# VARIANCE REQUEST FORM

Applicant/Owner Name: Thomas and Rita Sullivan	
Applicant/Owner Address: 5566 Elmwood St. Littleton, CO 80120	
Subject Property Address: 5566 Elmwood St.	
Legal Description: <b>Lot 7 Block 7 Stark Brothers Woodlawn addition</b>	
Current zoning of subject property	R-3

## 5566 S. ELMWOOD STREET ISP

**From:** [Rita Sullivan](#)  
**To:** [Elizabeth Kay Marchetti](#)  
**Subject:** Re: 5566 Elmwood VAR21-0008  
**Date:** Sunday, August 29, 2021 7:22:39 PM  
**Attachments:** [image001.png](#)

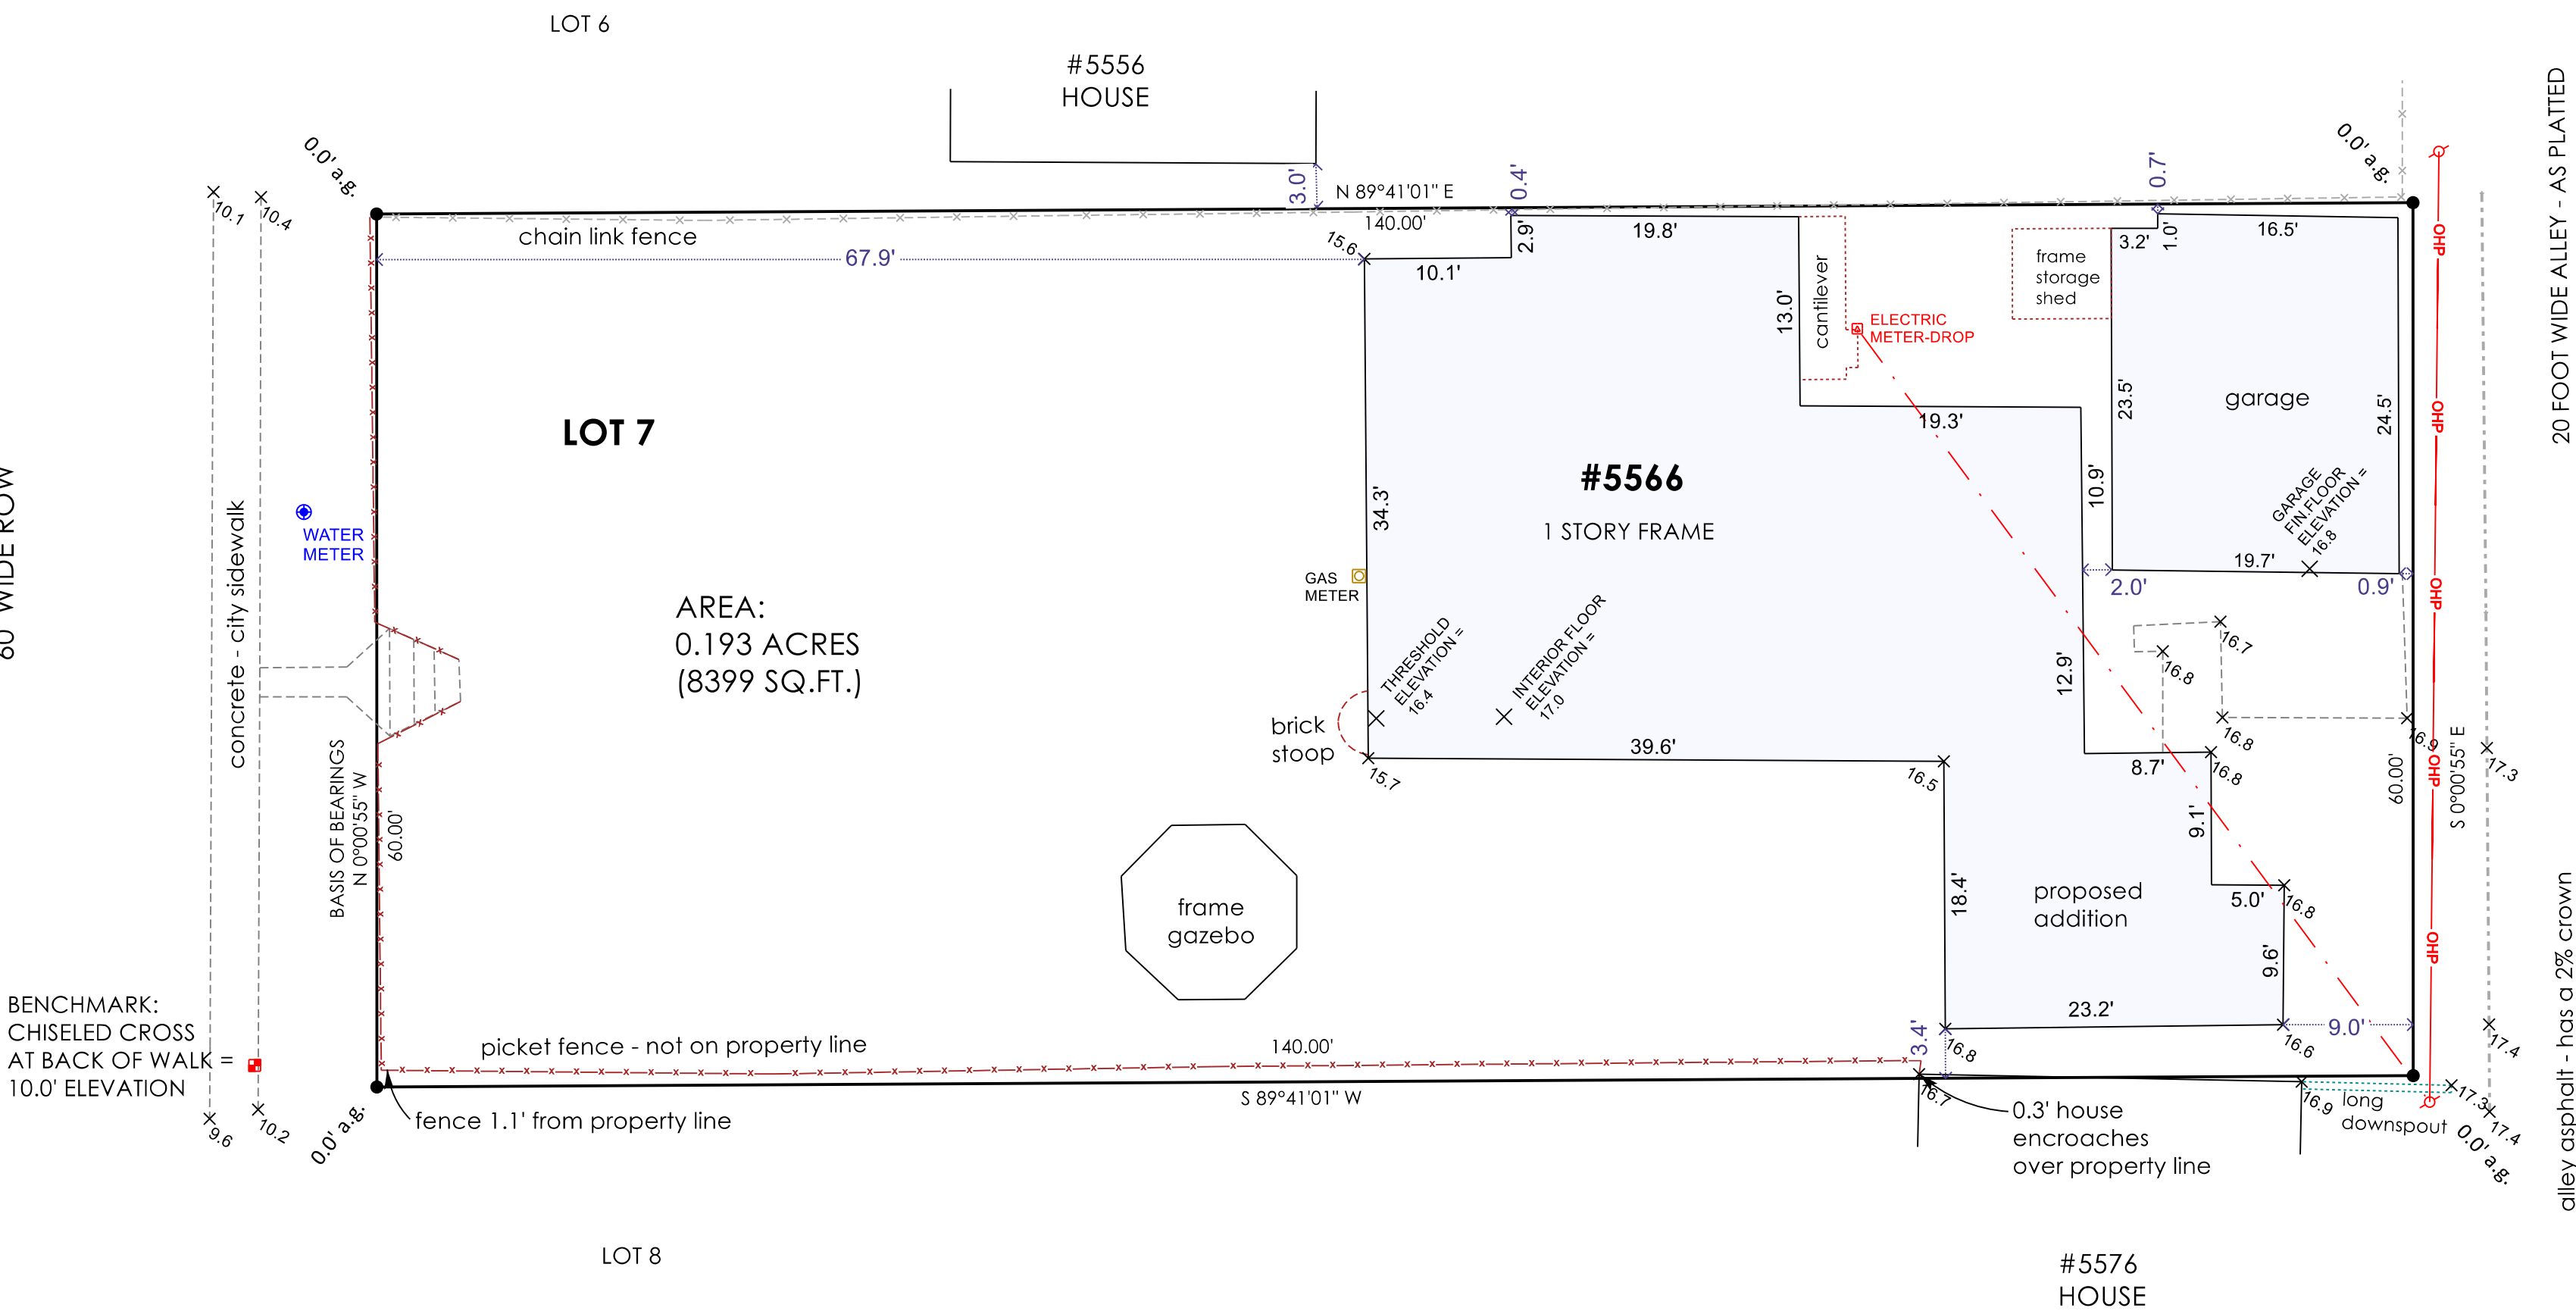
EXCEPT-the survey that your drawings are based on show a "Picket fence not on property line," along the southern property line...

Is the survey inaccurate??

The survey is accurate. Please note that the picket fence "not on the property line" runs from the west for 140 feet until it attaches to the neighbor's home. Our addition is not north of the fence but to the north of our neighbor's home.

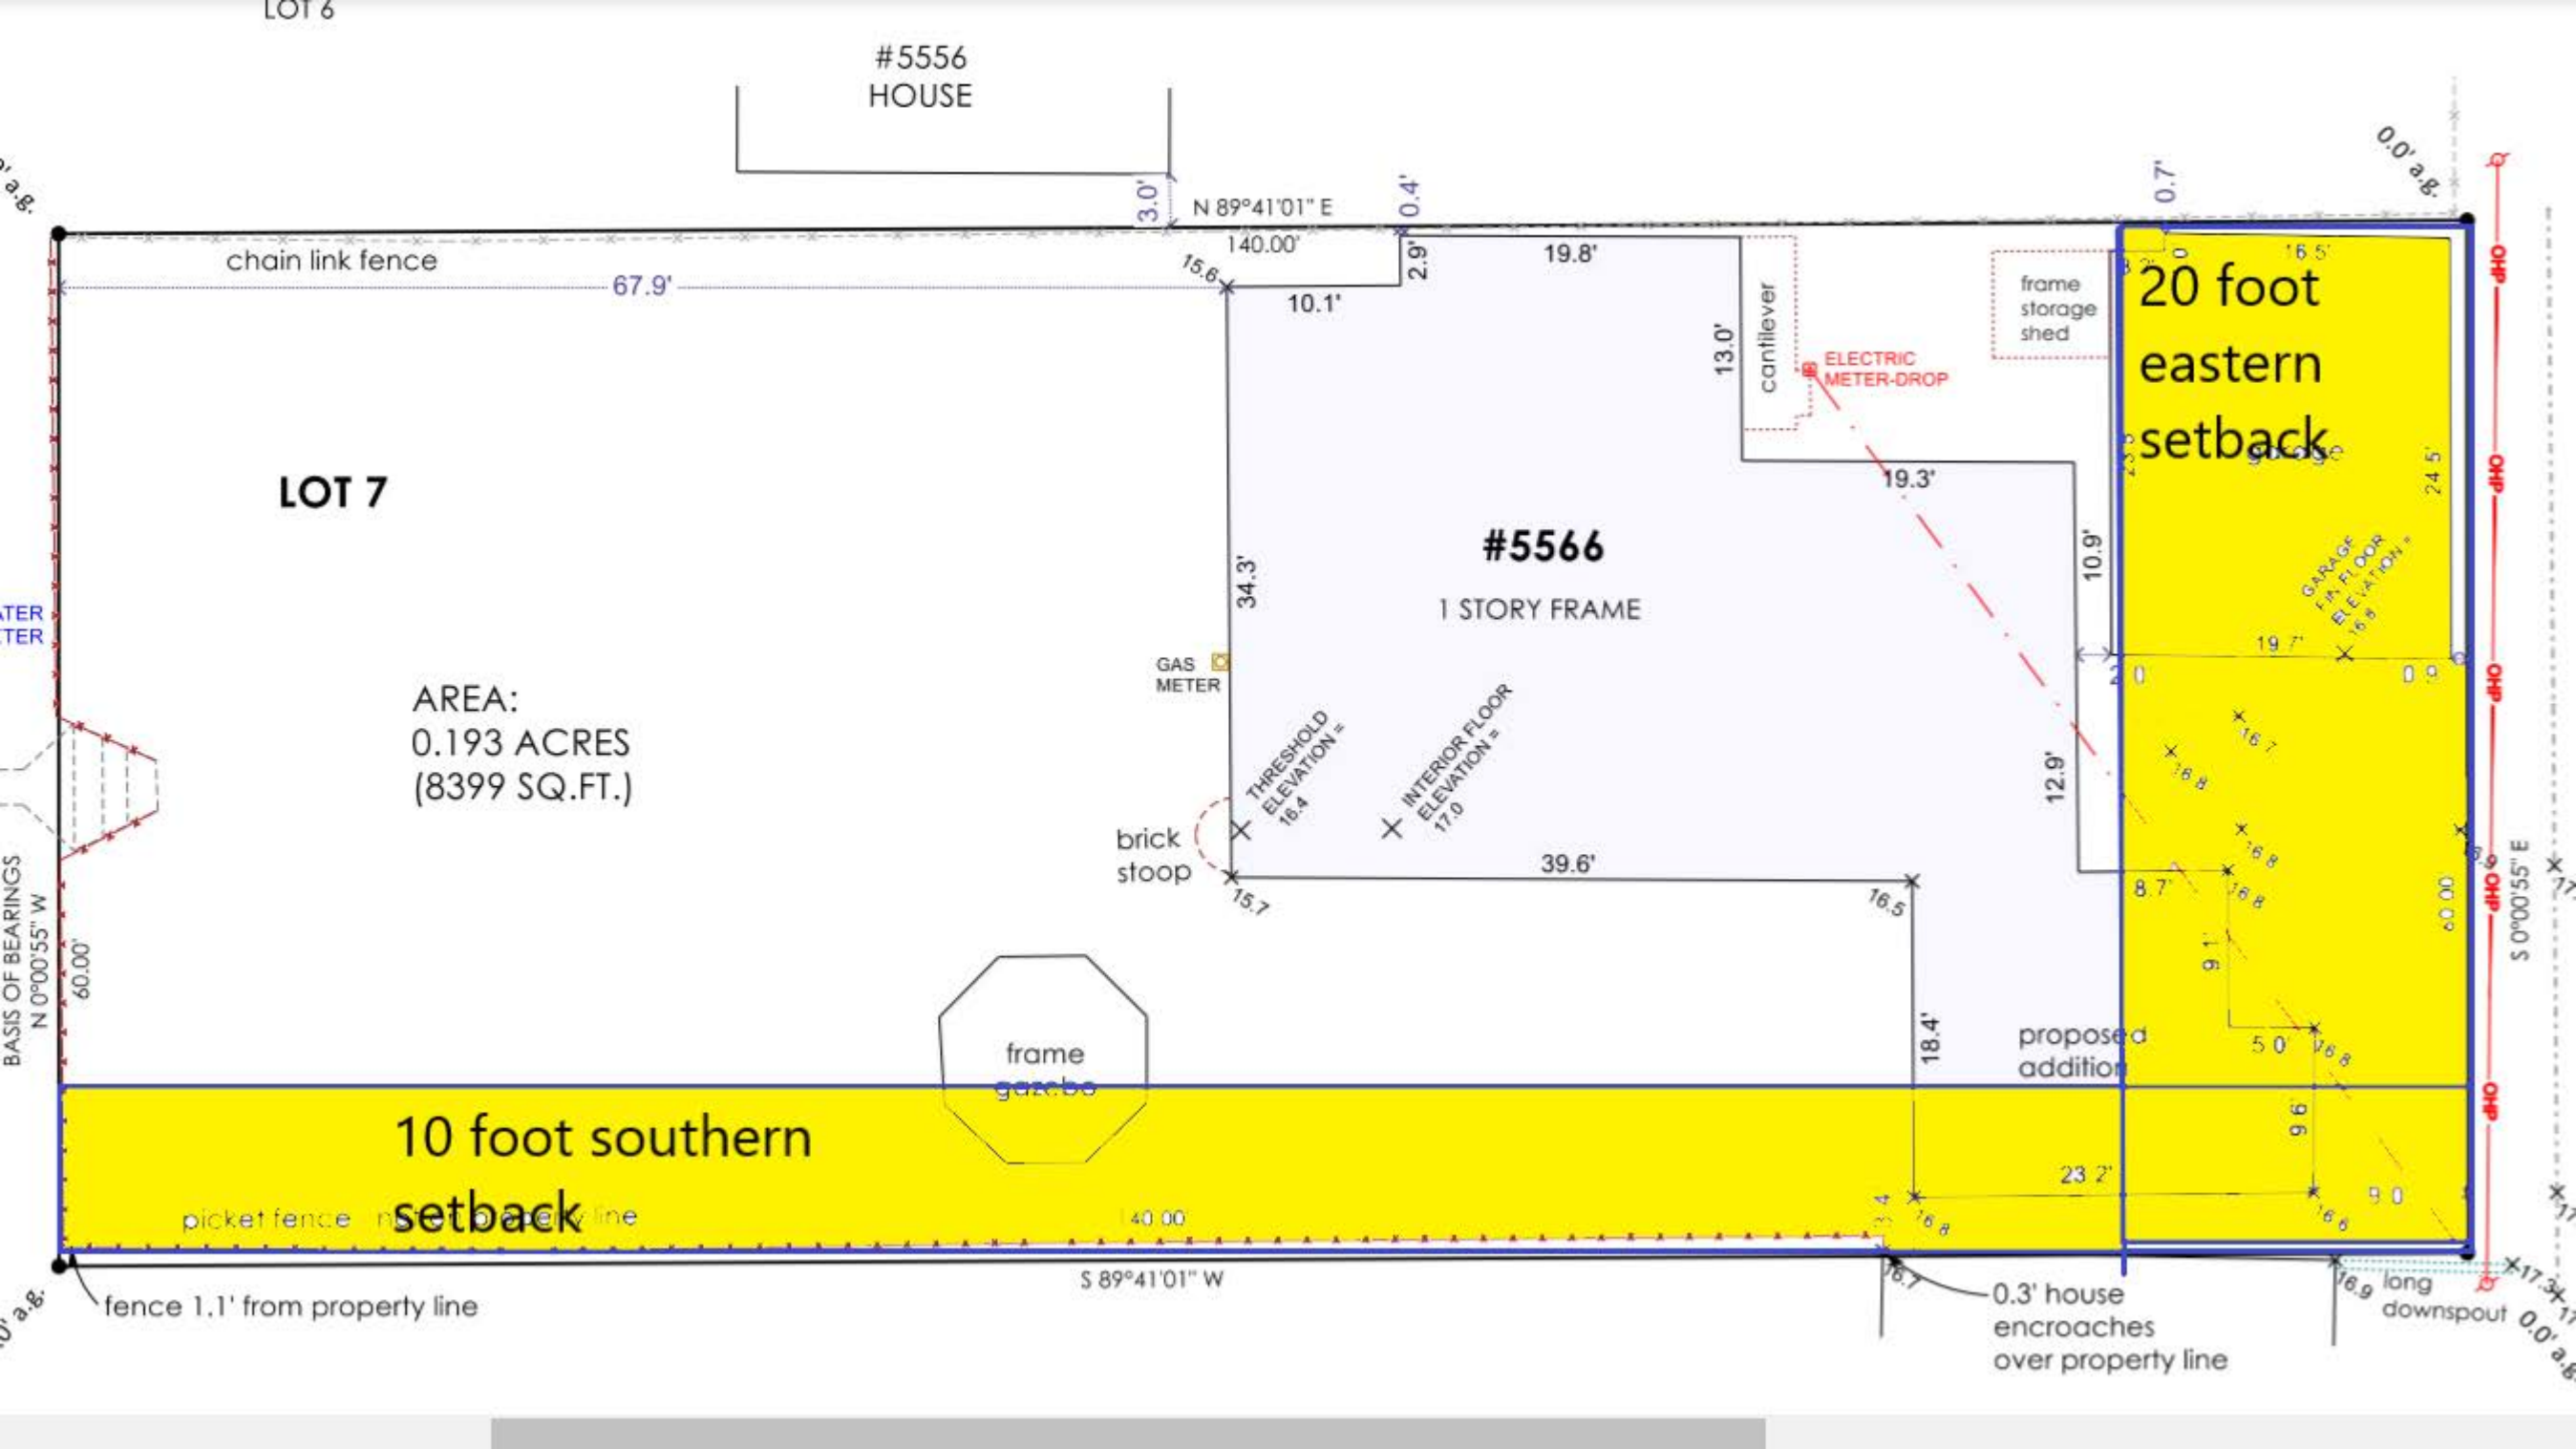
I've got a clarifying question: please let me know if the side yard setback request is for 5.6" or for 5.6'.

One more: what is the distance between the addition and fence to the south?

5.6 feet.

There is NO fence to the south of the addition. Our neighbors house to the south encroaches over our property line 4 in. So, in addition to an unusually narrow lot (smaller than code of 65 ft.), neighboring buildings on both north and south (also built during Arapahoe county days) do not adhere to the property line or setbacks and we are very compressed on this property.
